# AGENDA

ARCHITECTURAL REVIEW BOARD MEETING  
CITY HALL, 385 SOUTH GOLIAD STREET, ROCKWALL, TEXAS  
MARCH 11, 2025 IN THE CITY COUNCIL CONFERENCE ROOM AT 5:00 PM

**TO:** Planning and Zoning Commission  
**FROM:** Henry Lee, *Senior Planner*  
**DATE:** March 11, 2025  
**SUBJECT:** SP2025-007; *Amended Site Plan for 1407 S. Goliad Street*

**TO:** Planning and Zoning Commission  
**FROM:** Bethany Ross, *Planner*  
**DATE:** March 11, 2025  
**SUBJECT:** SP2025-008; *Amended Site Plan for 401 W. Rusk Street*

SHEET  
 A-4

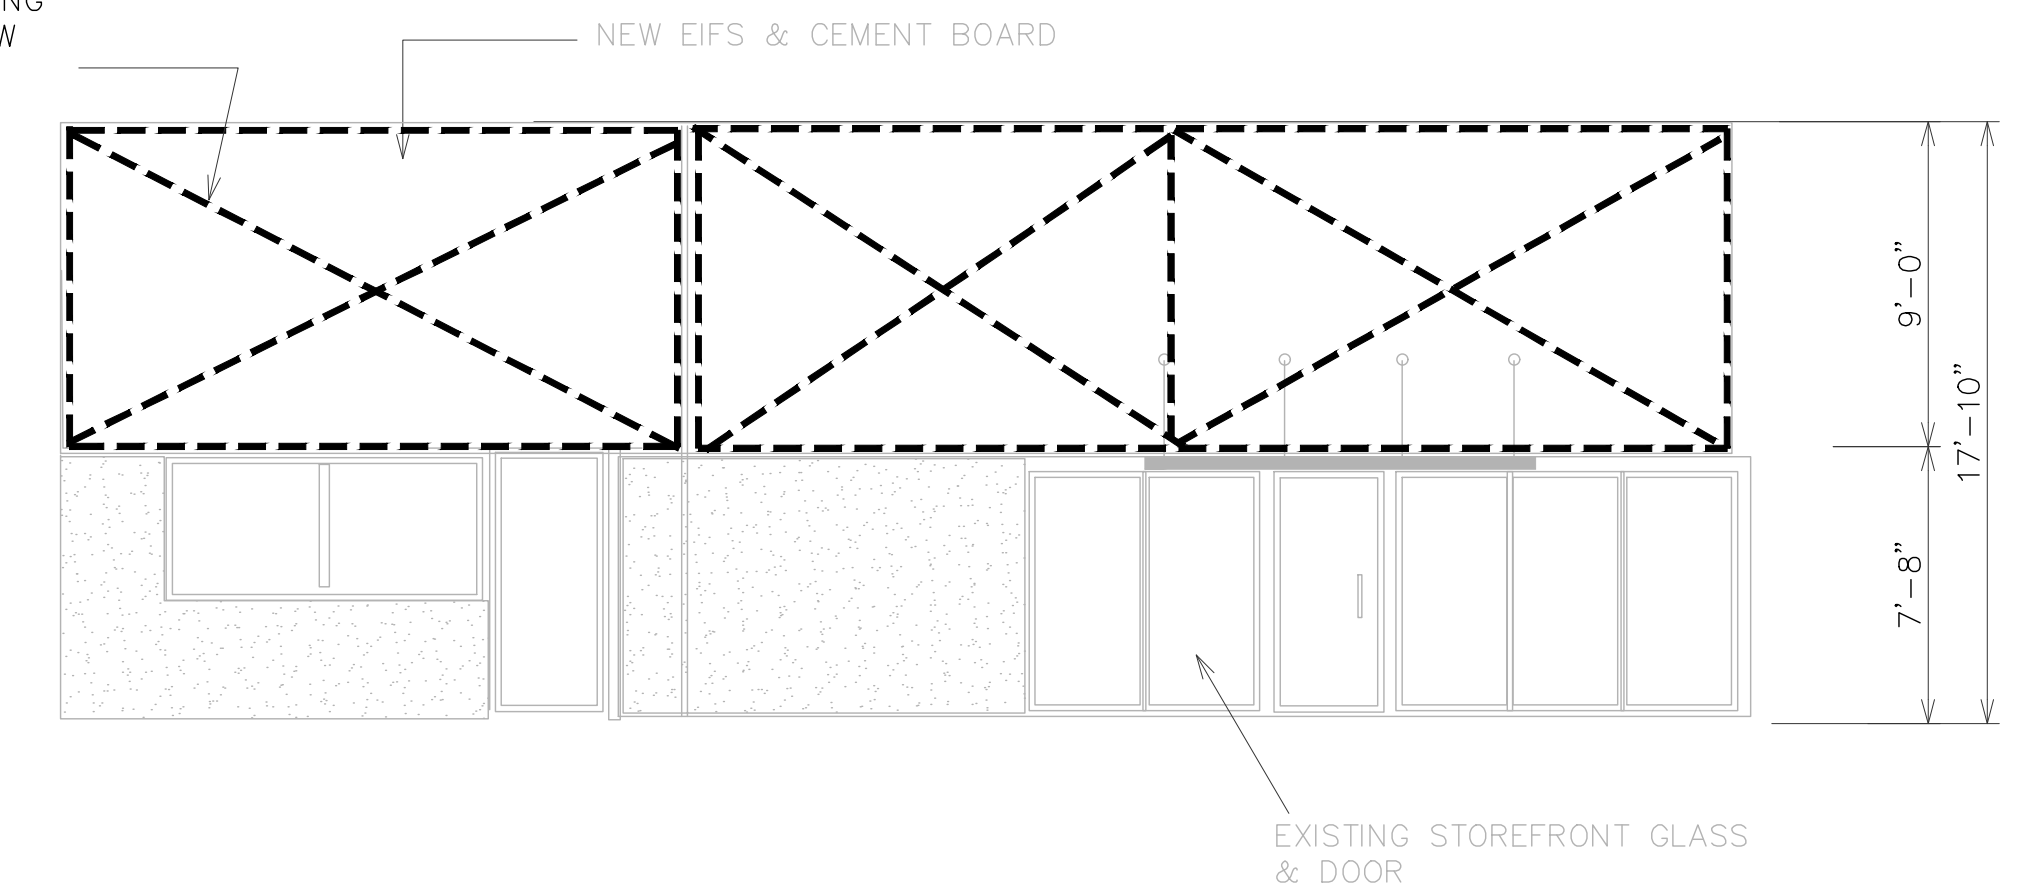
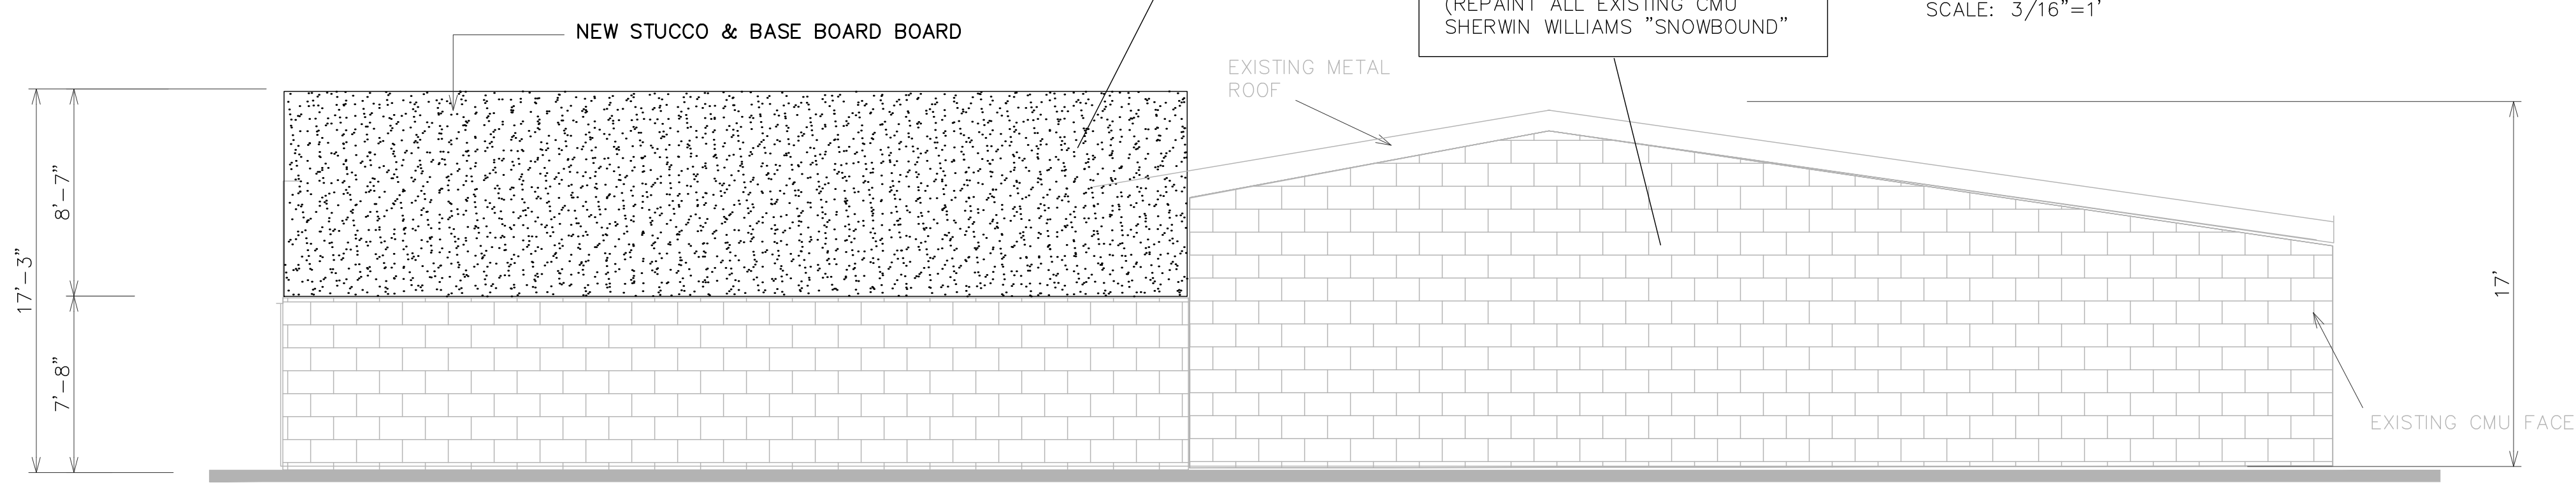
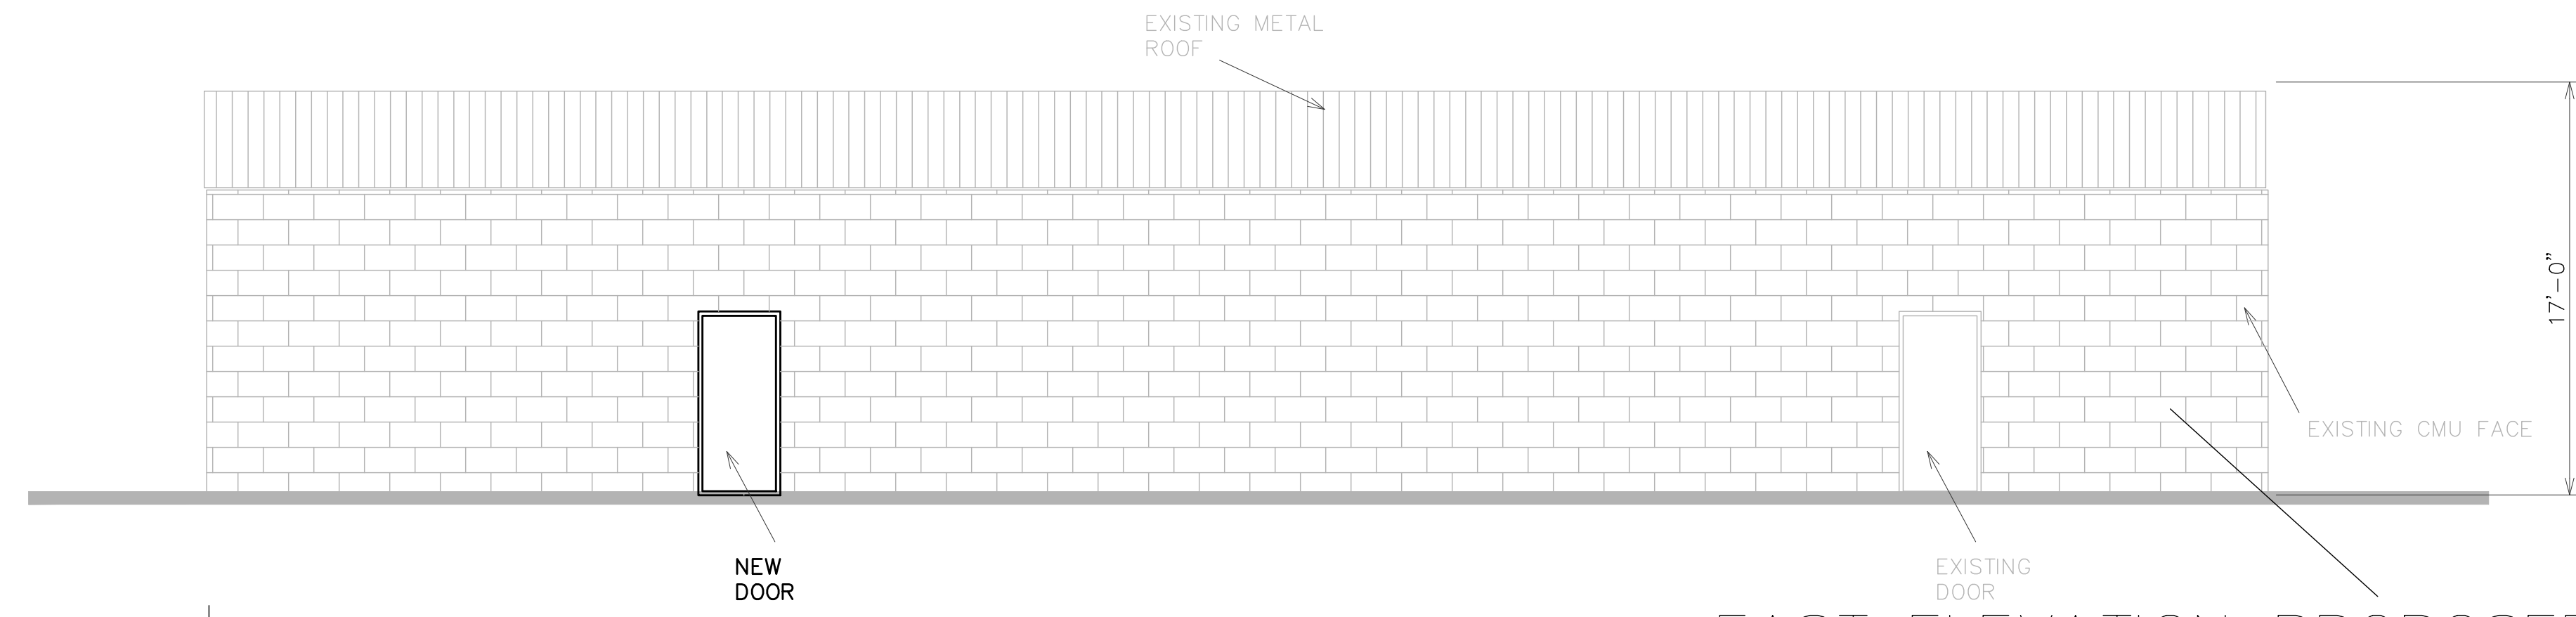
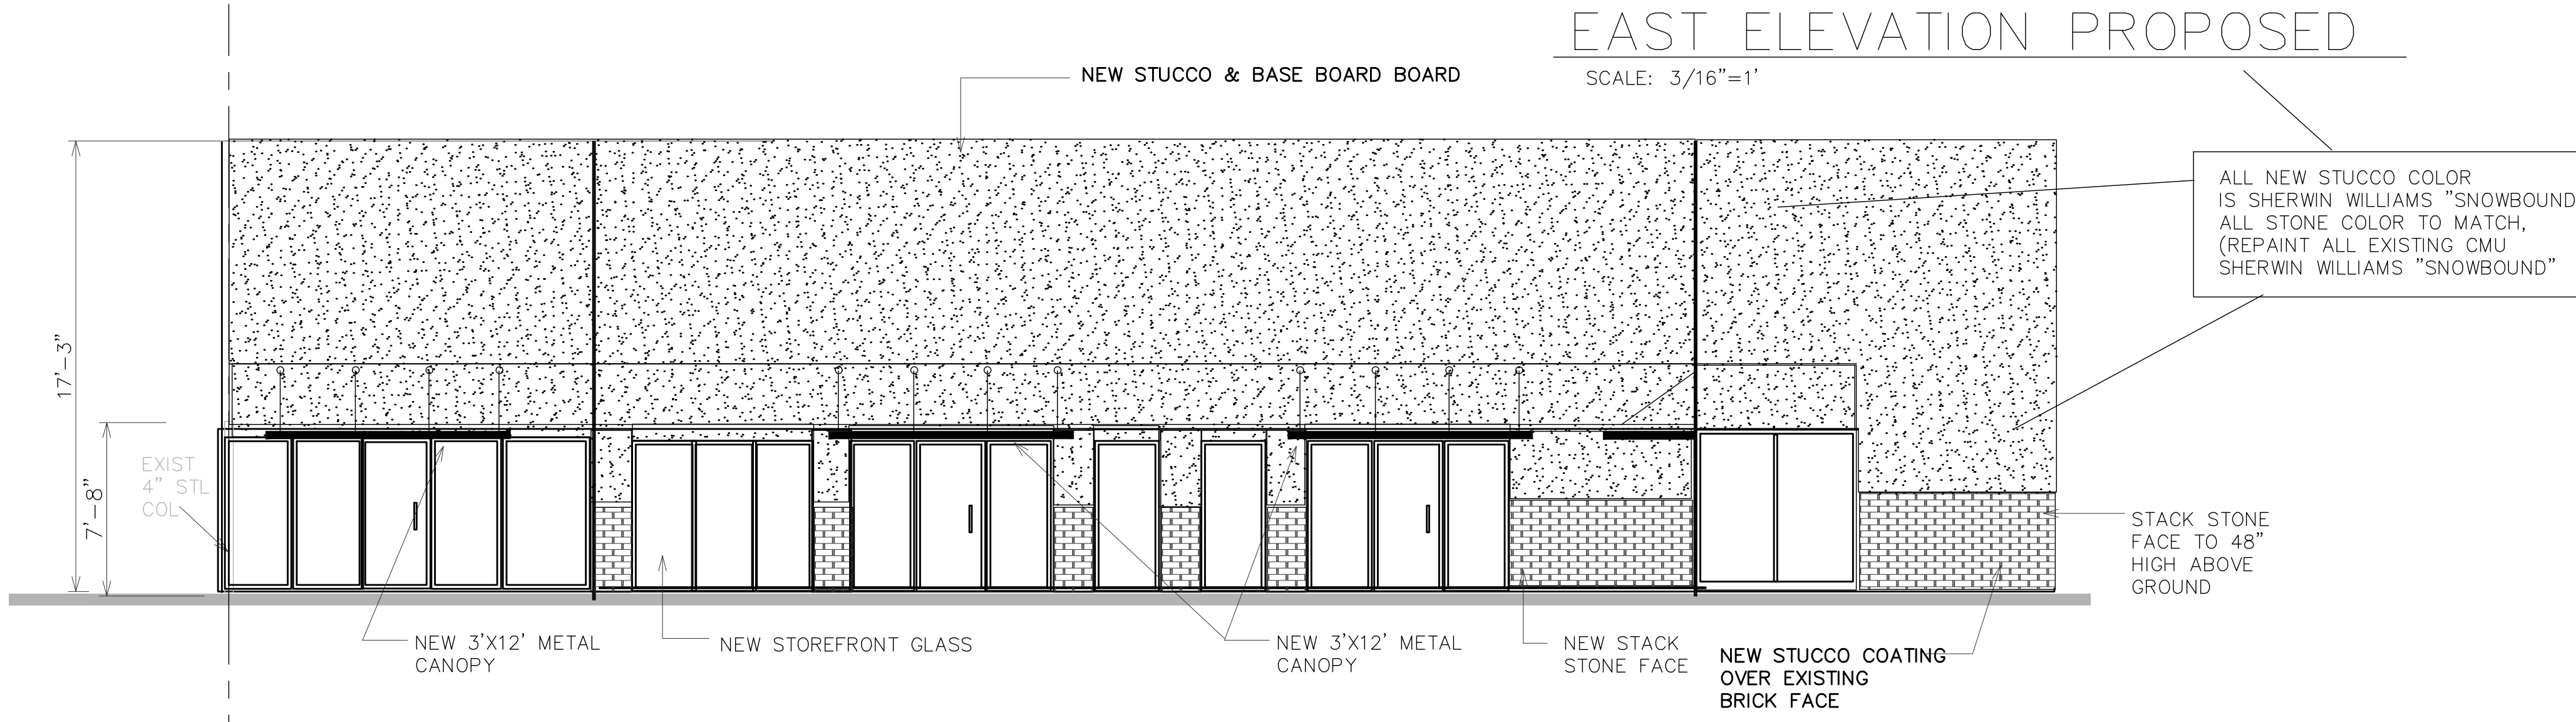
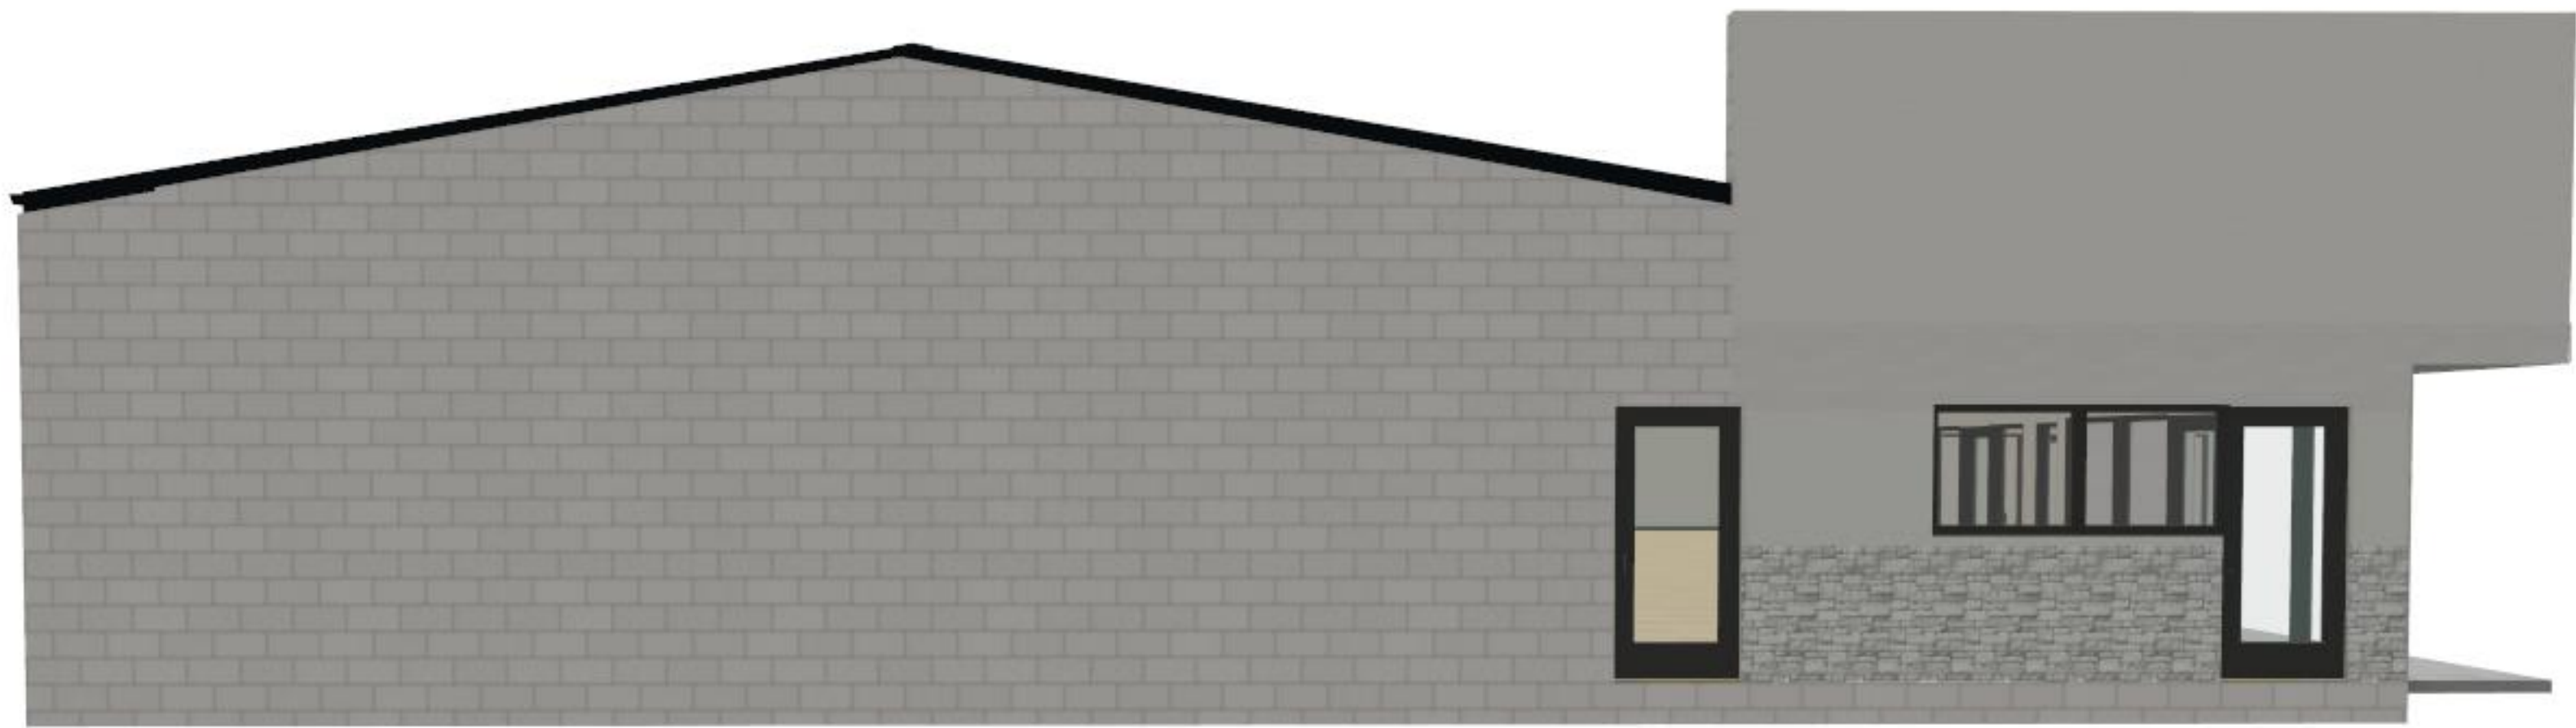
The original building elevations submit on February 25, 2025 indicated that [1] the parapet would be raised, [2] the parapet would be extended, and [3] stacked stone would be added to the front façade up to the canopy height. Due to inconsistencies in the building elevations and the building renderings the ARB approved a motion to recommend tabling this case, which the Planning and Zoning Commission granted by a vote of 5-0, with Commissioners Thompson and Deckard absent. The applicant has since submitted new building elevations and building renderings that are consistent with each other. Based on the new elevations the applicant is requesting to [1] to increase the parapet height, [2] extend the parapet, and [3] add a four (4) foot wainscot of stacked stone on the front and side façades.

According to Subsection 04.01(A), *Roof Design Standards*, of Article 05, *District Development Standards*, of the Unified Development Code (UDC), parapet systems must be "...enclosed on all sides..." and "...shall be finished on the interior side using the same materials as the exterior facing wall..." In this case, the proposed parapet extends across the front façade (*i.e. west façade*) and half-way down the side façades (*i.e. the north and south façades*). The applicant has indicated to staff that the increased height and expansion of the parapet is to "... maintain a consistent aesthetic ..." and allow for greater screening of the roof top units (*i.e. RTUs*). In addition, the applicant indicated that they are requesting to paint the back of the parapet due to cost and the lack of visibility of this portion of the building. In summary the applicant is requesting approval of an Amended Site Plan with variances to the [1] parapet system and [2] parapet materials. According to Subsection 09, *Exceptions and Variances*, of Article 11, *Development Applications and Review Procedures*, of the Unified Development Code (UDC), an applicant may request the Planning and Zoning Commission grant variances and exceptions to the provisions contained in the Unified Development Code (UDC), where unique or extraordinary conditions exist or where strict adherence to the technical requirements of the Unified Development Code would create an undue hardship. In addition, the code requires that the applicant provide compensatory measures that directly offset the requested variances and exceptions. At this time the applicant is proposing to plant five (5) gallon evergreen shrubs in front of the parking spaces that face onto S. Goliad Street. Staff should also point out that while the proposed improvements are not necessarily in conformance with the *General Overlay District Standards*, they do bring a legally non-conforming building closer to complying with the design criteria of the UDC, and this in itself can be considered a compensatory measure. Requests for exceptions and variances to the *General Commercial District Standards* and *General Overlay District Standards* are discretionary decisions for the Planning and Zoning Commission. Staff should note that a supermajority vote (*e.g. six [6] out of the seven [7] commissioners*) -- with a minimum of four (4) votes in the affirmative -- is required for the approval of a variance or exception.
